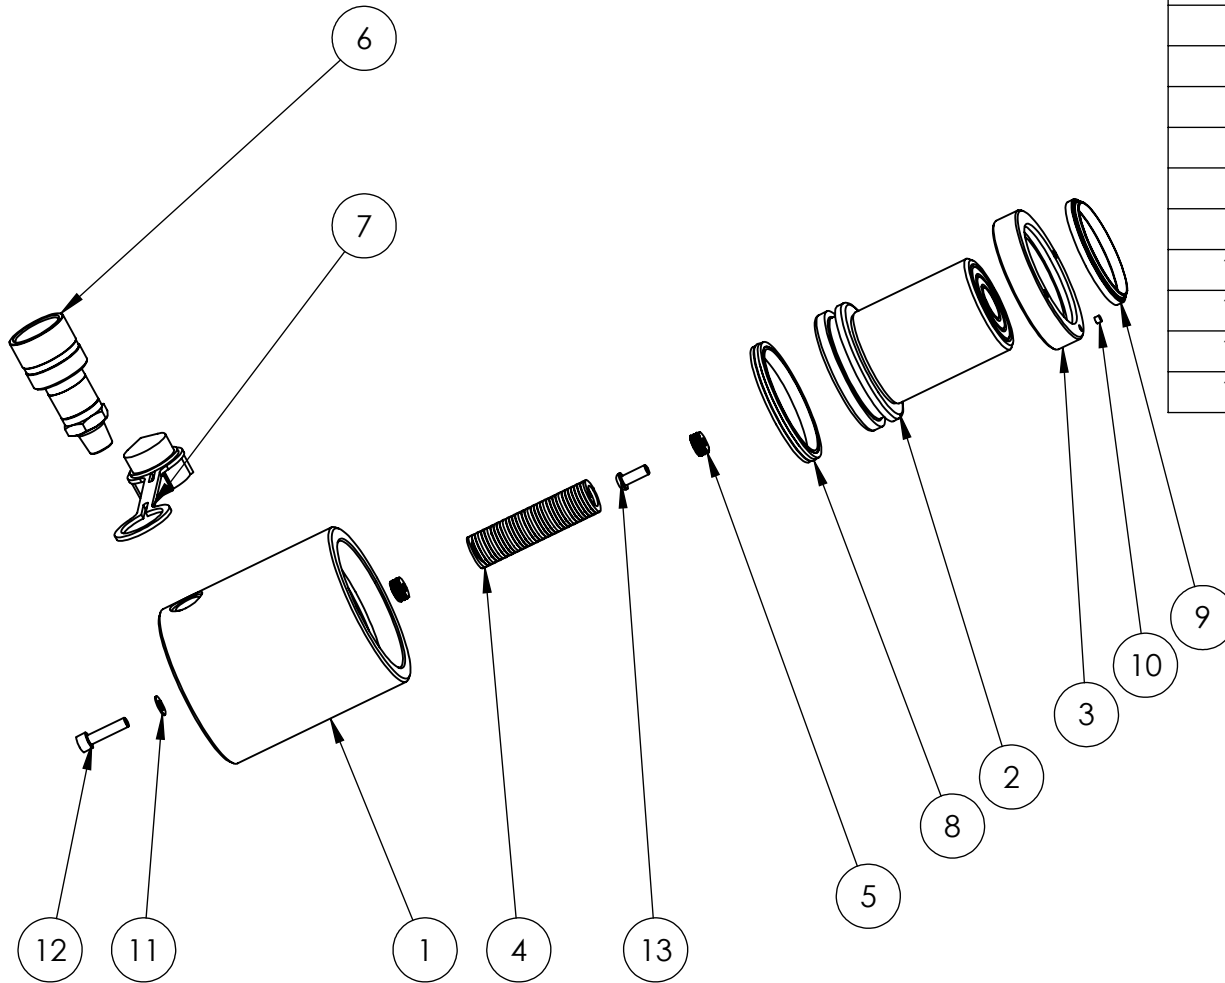
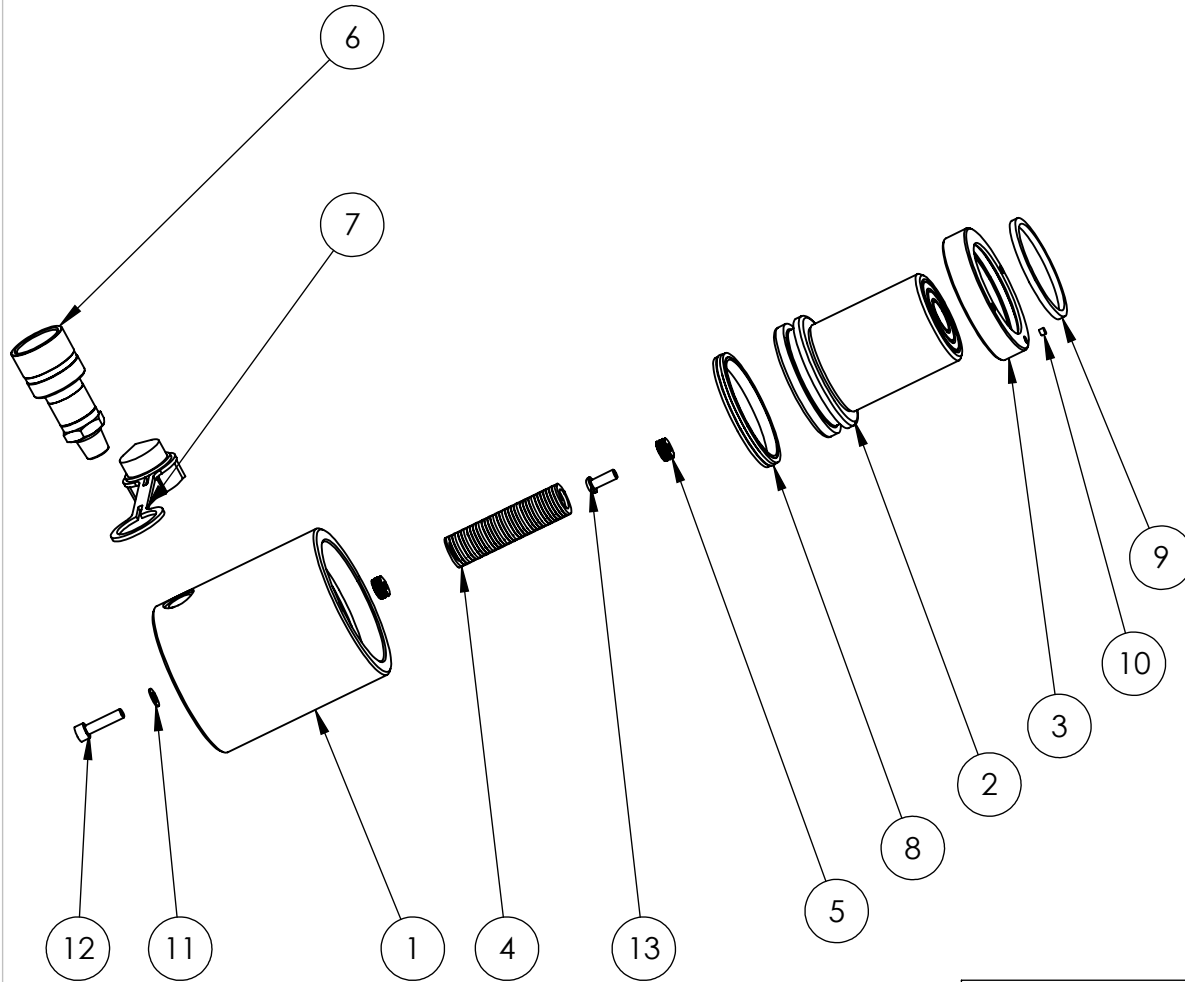
1. ITEMS MARKED X ARE AVAILABLE IN SERVICE KIT HLS30TP1-K ONLY
2. OBSOLETE PARTS. THE FOLLOWING PARTS WILL NEED TO BE ORDERED: 1 x PRC076FD003, 1 x SRC060SG003, 1 x SPC038TD003, 2 x SIC029TC001, 1 x BLC006JD035, 1 x BLC006JH025, AND REVISED SERVICE KIT HLS30TP2-K INSTEAD OF HLS30TP1-K.
3. IF SPRING IS REPLACED, INSERTS SHOULD ALSO BE REPLACED.
